NORTH HYKEHAM RELIEF ROAD NHRR STAGE 2 ROAD SAFETY AUDIT REPORT

Project name **North Hykeham Relief Road**
 Project no. **1620013942**
 Recipient **Balfour Beatty & Lincolnshire County Council**
 Document type **Report**
 Revision **C01**
 Date **21/10/24**
 Prepared by **S.Hawley**
 Checked by **G.Turner**
 Approved by **S.Hawley**
 Document no. **NHRR-RAM-HGN-HYKE-RP-CH-01038**
 Suitability Status **A4 - Approved & Accepted at Stage 4**

This report describes a Stage 2 Road Safety Audit (RSA) carried out on the design works associated with North Hykeham Relief Road (NHRR) and covers the Lincolnshire County Council (LCC) network and the National Highways (NH) network reported in a separate section.

LCC & NH PROBLEM LOCATION PLAN

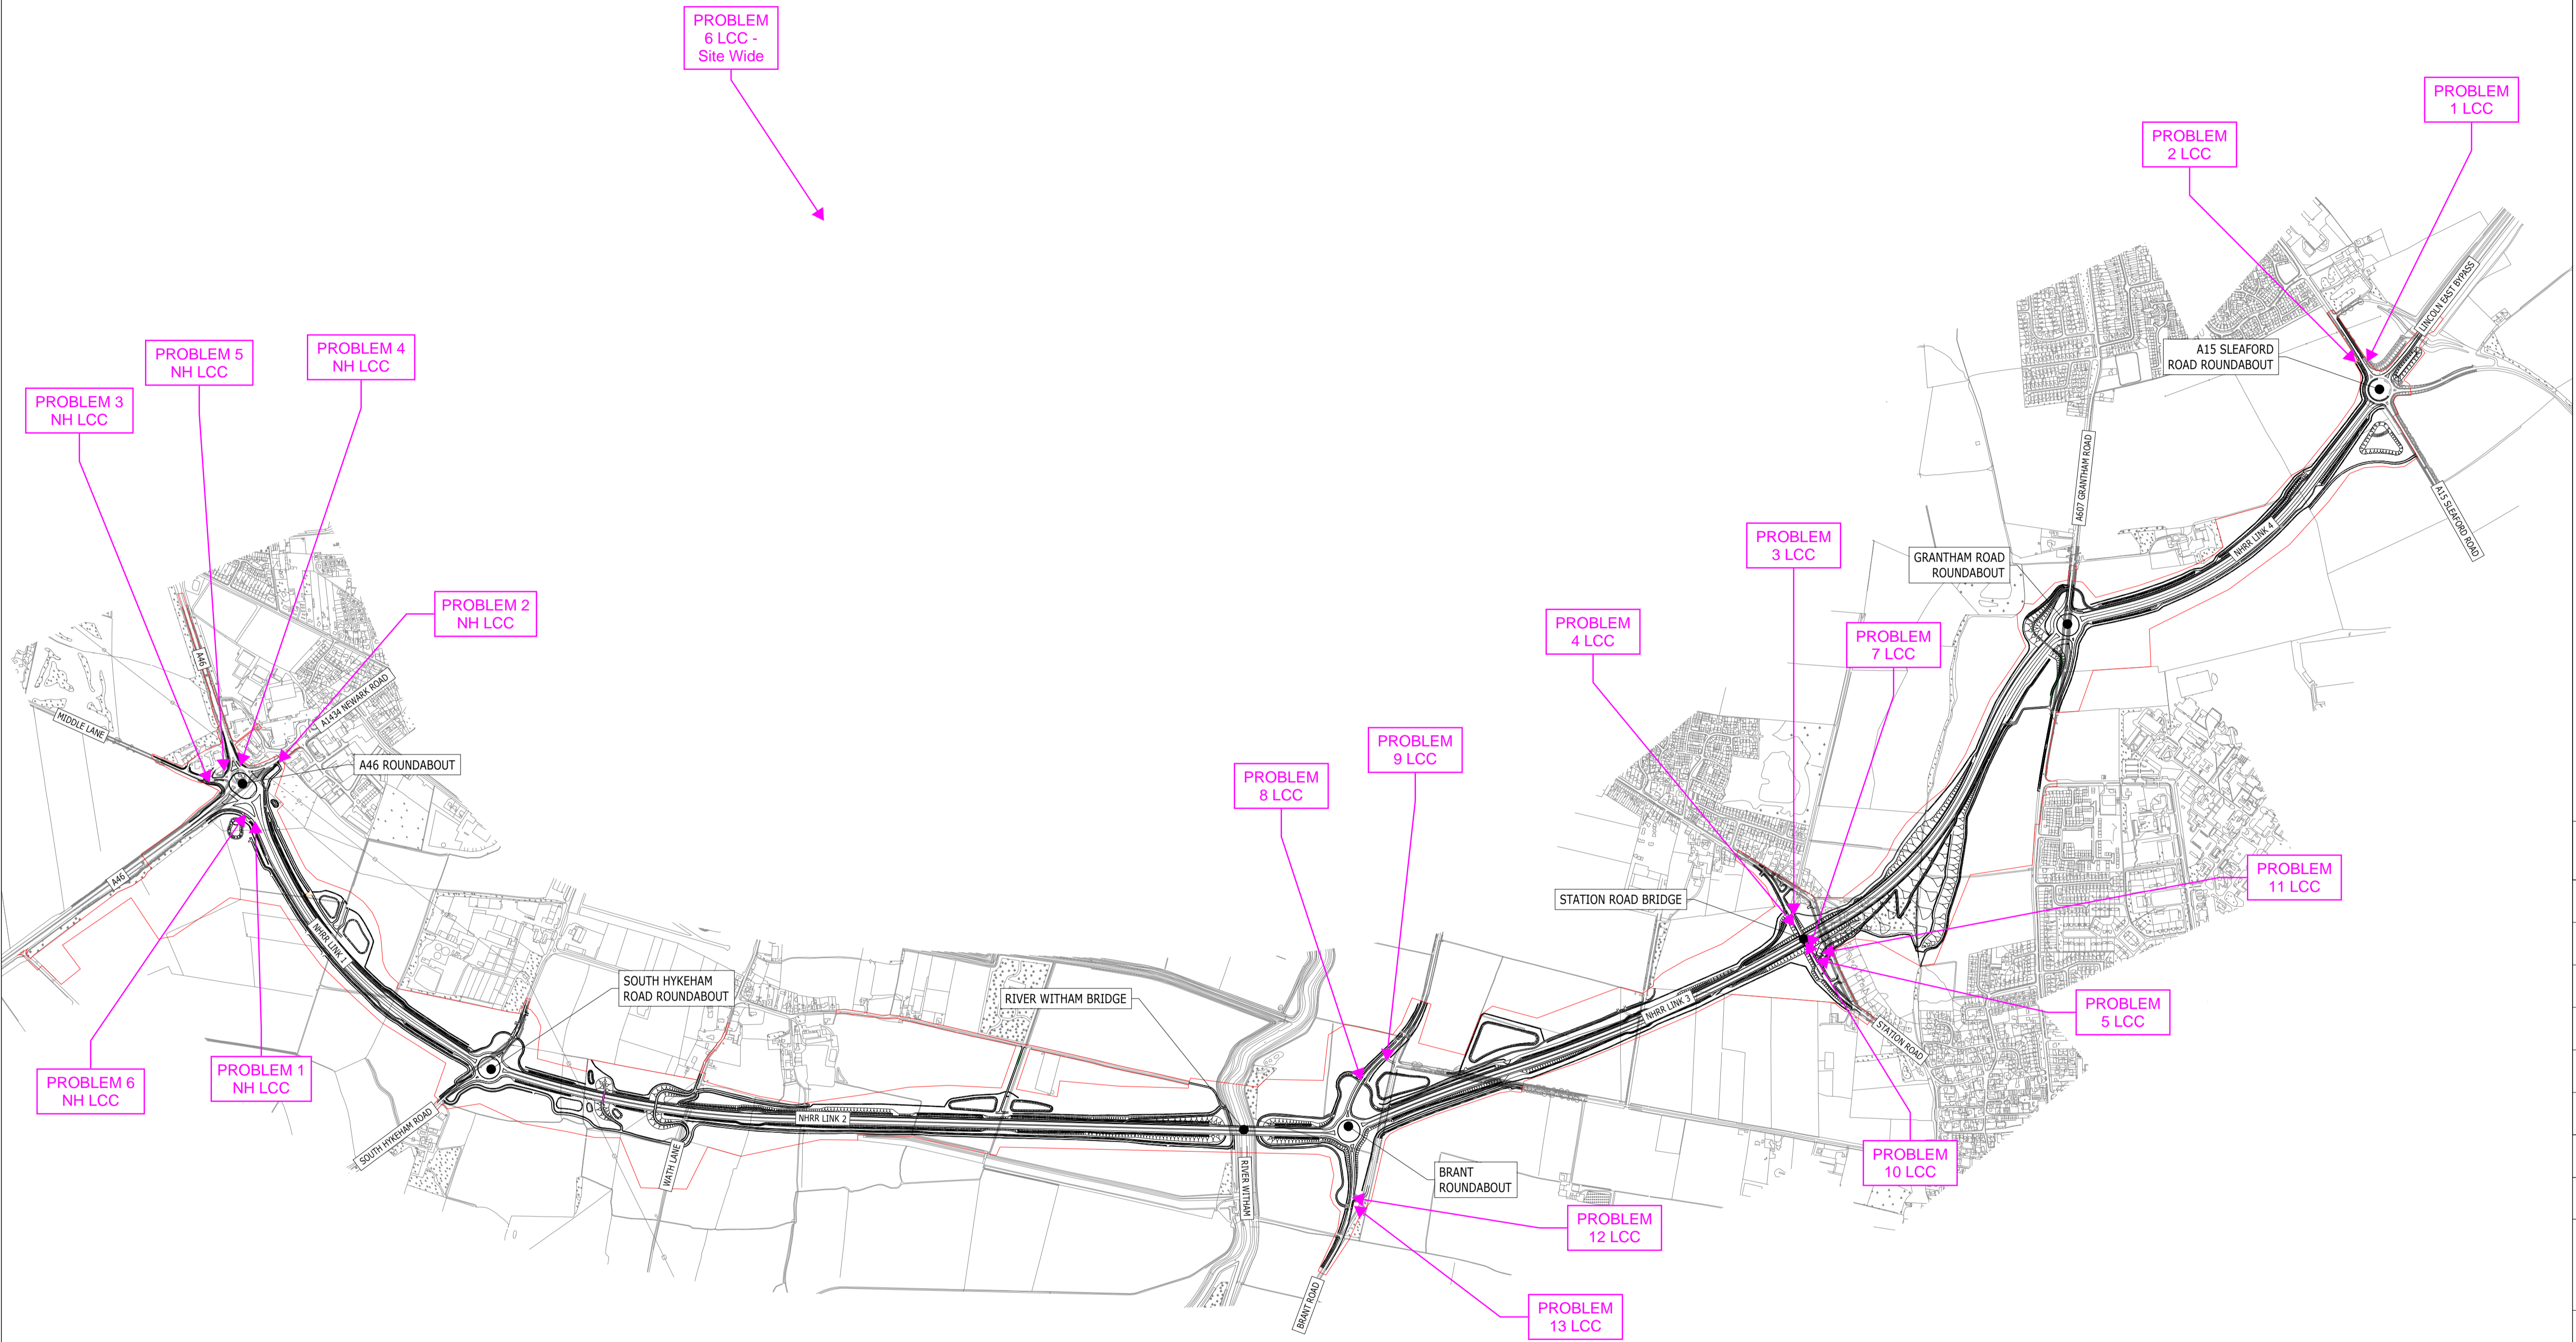
PROBLEM 1 NH LCC	
Location:	NHRR northbound carriageway towards North Hykeham Roundabout (Location 1 NH LCC on Plan in Appendix 1)
Plan:	NHRR-RAM-HGN-HYKE-DR-CH-00011 P04
Summary:	Nearside kerb line of SLTL alignment may result in side-swipe type collisions with personal injury occurring.
<p>The northbound NHRR approach to the Hykeham Roundabout diverges and a SLTL forms. At the start of the splitter island/end of the chevron zone the nearside kerb line appears to have a relatively 'tight' radius curve. This sharpness of the proposed alignment may result in vehicles deviating into the adjacent lane leading to side-swipe type collisions with personal injury occurring.</p>	
RECOMMENDATION	
It is recommended that the nearside kerb line should be redesigned to provide a 'smooth' alignment to mitigate the risk of a Lane 1 vehicle deviating into Lane 2.

PROBLEM 2 NH LCC	
Location:	A1434 westbound carriageway towards North Hykeham Roundabout (Location 2 NH LCC on Plan in Appendix 1)
Plan:	NHRR-RAM-HSN-HYKE-DR-CH-12132 C01
Summary:	Local destination sign not a 'map' type which may lead to driver confusion resulting in side-swipe type collisions and personal injury.
Local destination sign is not a 'map' type. This may lead to driver confusion on the approach to, or at the roundabout resulting in unsafe vehicle manoeuvres such as late lane changes occurring, with possible side-swipe type collisions resulting in injury.	
RECOMMENDATION	
It is recommended that a local destination map type sign should be provided.

PROBLEM 3 NH LCC	
Location:	Service area off Middle Lane at North Hykeham Roundabout (Location 3 NH LCC on Plan in Appendix 1)
Plan:	NHRR-RAM-HSN-HYKE-DR-CH-12132 C01
Summary:	Lack of service area design signage may result in late lane changing resulting in side-swipe type collisions with personal injury occurring.
From the information provided there does not appear to be any destination signage directing drivers to the service area. This may result in late decision making, late lane changing with side-swipe type collisions and personal injury occurring.	
RECOMMENDATION	
It is recommended that at all approach arms of North Hykeham Roundabout destination signs directing drivers to the service area should be provided.

PROBLEM 4 NH LCC	
Location:	Southbound A46 lane 1 approach to Hykeham Roundabout (Location 4 NH LCC on Plan in Appendix 1).
Plan:	NHRR-RAM-HML-HYKE-DR-CH-01040 C01
Summary:	Entry path radius appears to be greater than 100m in the vicinity of the stop line and may result in high vehicle speeds with loss of control type collisions and personal injury occurring.
<p>Although it is recognised that the roundabout junction will be signalised drivers travelling southbound via the A46 Lane 1 (ahead and left indicated) may receive a 'green wave' and may not therefore need to appreciably reduce their speed. The entry path radius appears to be greater than 100m in the vicinity of the stop line and continuing along the vehicle path. This may result in high vehicle speeds with loss of control type collisions and personal injury occurring. The Audit Team note from the RSA brief that no Departure from Standard has been applied for in relation to entry path curvature at this location.</p>

PROBLEM 5 NH LCC	
Location:	Middle Lane northern verge unofficial worn path at Hykeham Roundabout (Location 5 NH LCC on Plan in Appendix 1).
Plan:	NHRR-RAM-HKF-HYKE-DR-CH-11112 P02 and 11114 P02
Summary:	Risk of pedestrian / vehicle collisions occurring while crossing A46 between services area and restaurant leading to possible personal injury.
<p>It is recognised that crossing facilities to the south of the roundabout will be provided, which may help to reduce the number of NMUs currently crossing the A46. However, the current, as observed (and arguably more direct) route is approximately four times shorter than the proposed route being offered. Consequently, there is a concern that some NMUs will continue to use the current, more direct, route. This may result in pedestrian/vehicle conflicts leading to personal injury.</p>	
RECOMMENDATION	
It is recommended that appropriate NMu crossing facilities should be provided which allow for existing and established desire lines and which sufficiently cater for the existing user demand.

PROBLEM 6 NH LCC	
Location:	NHRR N/B approach the Hykeham Roundabout (Location 6 NH LCC on Plan in Appendix 1).
Plan:	NHRR-RAM-HSL-HYKE-DR-TS-14101 P05.1 and NHRR-RAM-HKF-HYKE-DR-CH-11112 P02
Summary:	Limited visibility to both primary traffic signals may lead to rear-end shunt type collisions occurring with personal injury.
<p>If the nearside maintenance lay-by is occupied possibly by a high sided vehicle there will be limited visibility to both primary traffic signals which may result in drivers not seeing a red signal aspect resulting in overshoot or late braking leading to side swipe, shunt type collisions occurring leading to personal injury or collision with NMUs on the signalised crossing leading to pedestrian injury.</p>	
RECOMMENDATION	
<p>It is recommended that the maintenance lay-by should be relocated to a more appropriate location.</p>

PROBLEM 1 LCC	
Location:	Sleaford Road Roundabout (Location 1 LCC on Plan in Appendix 1).
Plan:	NHRR-RAM-HSN-HYKE-DR-CH-12165 C01
Summary:	Equestrians 'Pegasus' type crossing is not proposed although existing signing indicates that equestrians are permitted to use the shared-use facility. This may lead to equestrians crossing Sleaford Road in a location without adequate facilities being in place, resulting in collisions with other road users and possible personal injury.
<p>An equestrian compatible 'Pegasus' type crossing is not proposed although existing signing indicates that form of road user is permitted to use the proposed shared-use facility. This may lead to equestrians crossing Sleaford Road in a location without adequate facilities being in place, resulting in collisions with other road users and possible personal injury. It is noted that an existing public bridleway connects with Bloxholm Lane which may indicate that the proposed signal controlled NMU crossing is not correctly located.</p>

PROBLEM 2 LCC	
Location:	Sleaford Road Roundabout (Location 2 LCC on Plan in Appendix 1).
Plan:	NHRR-RAM-HSL-HYKE-DR-TS-14501 C02
Summary:	De-restricted speed limit at location of proposed NMU signal-controlled crossing may result in vehicles failing to stop resulting in collisions with NMUs on the crossing and personal injury.
De-restricted speed limit at location of proposed NMU signal-controlled crossing may result in vehicles failing to stop or late-braking leading to overshoots and possible collisions with NMUs on the crossing with personal injury occurring.	
RECOMMENDATION	
<p>It is recommended that measures, such as speed limit reduction, should be introduced to reduce the likelihood of vehicles failing to stop or having to brake late on the approach to the signal-controlled crossing owing to excessive speeds.</p> <p>It is noted that an existing speed limit of 30mph is in place on the entrance to Bracebridge Heath, approximately 200m beyond the proposed signal-controlled NMU crossing.</p> <p>Furthermore, Grantham Road Roundabout has a 40mph speed limit proposed immediately north of the roundabout before the NMU crossing.</p>

PROBLEM 3 LCC	
Location:	Station Road (Location 3 LCC on Plan in Appendix 1).
Plan:	NHRR-RAM-HSN-HYKE-DR-CH-12167 C01
Summary:	Downhill approach to western off-carriageway shared-use route has short lead in. This may result in loss of control type collisions with personal injury.
The downhill approach to the off-carriageway shared-use facility has a short length of transition and stopping zone in advance of the uncontrolled crossing. This limited length of transition in advance of the crossing may lead to late braking, skidding and overshoots into the carriageway with a risk of collisions with vehicles and personal injury.	
RECOMMENDATION	
It is recommended that the lead-in, transition length, in advance of the uncontrolled crossing location, should be increased to enable cyclists to steadily reduce their speed and better position themselves in a safe manner before crossing Station Road at the uncontrolled crossing.

PROBLEM 4 LCC	
Location:	Station Road (Location 4 LCC on Plan in Appendix 1).
Plan:	NHRR-RAM-HSN-HYKE-DR-CH-12167 C01
Summary:	Central refuge width is insufficient leading to cycle/passing vehicle collisions and personal injury.
<p>The uncontrolled crossing mid-crossing refuge width is insufficient, and the adjacent carriageway lane width appears to be less than the desirable minimum standard. This combination to physical dimensions may lead to a cycle oversailing into the carriageway with a consequent risk of it being hit by a passing vehicle leading to personal injury.</p>	
RECOMMENDATION	
<p>It is recommended that the width of both the mid-crossing refuge and the adjacent running lanes should be increased. The absence of warning signage including keep left bollards, may further increase the risk of a collision occurring with resultant injury.</p>

PROBLEM 5 LCC	
Location:	Station Road (Location 5 LCC on Plan in Appendix 1).
Plan:	NHRR-RAM-HSN-HYKE-DR-CH-12167 C01
Summary:	Cyclists failing to stop at junction with Station Road carriageway leading to collisions with passing vehicles and personal injury.
<p>The proposed junction of the shared-use facility on the southeast corner of Station Road Bridge has insufficient signage and physical features to warn NMUs, in particular cyclists, that they are approaching Station Road. This may lead to cyclists overshooting and colliding with passing vehicles resulting in personal injury.</p>	
RECOMMENDATION	
<p>It is recommended that the level of warning signage, road markings and physical features, such as corduroy paving, should be increased and / or included in the proposals to provide NMUs with advance warning.</p>

PROBLEM 7 LCC	
Location:	Station Road (Location 7 LCC on Plan in Appendix 1).
Plan:	NHRR-RAM-LSI-HYKE-DR-CH-00111
Photograph	Photo D in Appendix 2
Summary:	Lack of verge on eastern side of realigned Station Road may lead to insufficient shared-use width for NMUs leading to collisions with other NMUs or with road restraint system (RRS) resulting in personal injury.
There does not appear to be a proposed verge along the eastern side of realigned Station Road. This may lead to insufficient shared-use width for NMUs with a risk of collisions with other NMUs or with a RRS occurring with possible personal injury.	
RECOMMENDATION	
It is recommended that both the shared-use route and a verge should be included along the eastern side of the realigned Station Road as part of the proposals to provide sufficient space for highway features such as a RRS and to allow NMU users to safely travel along the eastern side of Station Road on the approach to the proposed Station Road Overbridge.

PROBLEM 8 LCC	
Location:	Brant Road Roundabout (Location 8 LCC on Plan in Appendix 1).
Plan:	NHRR-RAM-HSL-HYKE-DR-TS-14301 C02
Summary:	De-restricted speed limit at location of proposed NMU signal-controlled crossing may result in vehicles failing to stop leading to collisions with NMUs on the crossing and personal injury.
De-restricted speed limit at location of proposed NMU signal-controlled crossing may result in vehicles failing to stop or late-braking leading to overshoots and possible collisions with NMUs on the crossing with personal injury occurring.	
RECOMMENDATION	
It is recommended that measures, such as speed limit reduction, should be introduced to reduce the likelihood of vehicles failing to stop or having to brake late on the approach to the signal-controlled crossing owing to excessive speeds. It is noted that Grantham Road Roundabout has a 40mph speed limit proposed immediately north of the roundabout before the NMU crossing.

PROBLEM 9 LCC	
Location:	Brant Road junction with Somerton Gate Lane (Location 9 LCC on Plan in Appendix 1).
Plan:	NHRR-RAM-HSN-HYKE-DR-CH-12149 P05
Summary:	Lack of road markings may lead to vehicles, particularly during the hours of darkness, over-running the junction and colliding with vehicles travelling along Brant Road.
Lack of road markings including give-way markings, may lead to vehicles travelling along Somerton Gate Lane towards Brant Road, particularly during the hours of darkness, over-running the junction and colliding with vehicles travelling along Brant Road. this may lead to personal injury.	
RECOMMENDATION	
It is recommended that appropriate warning signage and markings should be provided at this priority junction.

PROBLEM 10 LCC	
Location:	Station Road (Location 10 LCC on Plan in Appendix 1).
Plan:	NHRR-RAM-SBR-BR04-DR-CB-10101
Summary:	Provision of high containment 'Trief' type kerb may lead to an errant vehicle being projected upwards upon impact resulting in injury.
It is unclear why a high containment 'Trief' type kerb has been specified on Station Road overbridge as this may lead to an errant vehicle being projected upwards upon impact resulting in personal injury.	
RECOMMENDATION	
It is recommended that unless a Departure from Standard is provided for this situation then the height of the kerb upstand should be limited to 75mm to minimise the risk of an errant vehicle being projected upwards upon impact on the proposed Station Road Overbridge.

PROBLEM 11 LCC	
Location:	Station Road (Location 11 LCC on Plan in Appendix 1).
Plan:	NHRR-RAM-LSI-HYKE-DR-CH-00110 P03
Photograph	Photo E in Appendix 2
Summary:	Excessively steep/unsafe longitudinal gradients along shared-use facility on the eastern side of Station Road may lead to slips/falls resulting in injury.
From the information provided it appears that the east/west shared-use facility ties into the shared-use on the eastern side of Station Road at a steep gradient. This may result in NMU slips/falls with possible personal injury occurring.	
RECOMMENDATION	
It is recommended that the vertical alignments of all shared-use routes should be reviewed and amended to ensure that excessively steep/unsafe gradients are avoided.

PROBLEM 12 LCC	
Location:	Brant Road (Location 12 LCC on Plan in Appendix 1).
Plan:	NHRR-RAM-HML-HYKE-DR-CH-01302 P04.1
Photograph	Photo F in Appendix 2
Summary:	The lack of positive gradients in the proximity of chainage 250 may result in a vehicle losing control leading to occupant personal injury.
<p>From the information provided there appears to be a lack of positive gradients and particularly at the junction bellmouth in the proximity of chainage 250. When combined with the 'de-restricted' speed limit (60mph) and a design speed of 70kph, together with the associated horizontal and vertical geometry there is a concern that loss of control type collisions may occur leading to occupant personal injury.</p>	
RECOMMENDATION	
<p>It is recommended that measures should be provided possibly involving, but not necessarily limited to additional signage and road markings, to warn road users that although the speed limit is posted as 60mph the design speed of the road is less. It is noted that there does not appear to be any geometrical Departures from Standard in this location.</p>

PROBLEM 13 LCC	
Location:	Brant Road (Location 13 LCC on Plan in Appendix 1).
Plan:	NHRR-RAM-HDG-HYKE-DR-CH-05220 C02 and NHRR-RAM-HKF-HYKE-DR-CH-11130 C01
Photograph	Photo F in Appendix 2
Summary:	Unclear how NMUs should negotiate the proposed swale on the southeastern side of the junction. This may result in personal injury.
<p>It appears from the information provided that an NMU using the shared-use facility on the southeastern side of the junction and the uncontrolled crossing point, will have to negotiate a surface water drainage feature (swale). This may result in slips/trips or falls leading to possible personal injury.</p>	
RECOMMENDATION	
<p>It is recommended that the surface water drainage and the shared use facilities proposed are co-ordinated to ensure NMUs can safely negotiate the proposed works.</p>

RECOMMENDATION	
It is recommended that measures should be introduced to such that the likelihood of high vehicle speeds at this location is reduced.

RECOMMENDATION	
<p>It is recommended that co-ordination with the existing shared-use route should be carried out to ensure that all road users are presented with a consistent message. If necessary, i.e. dependant on demand but not limited to such a requirement, specific equestrian facilities should be provided which may include a 'Pegasus' type signal-controlled crossing.</p>
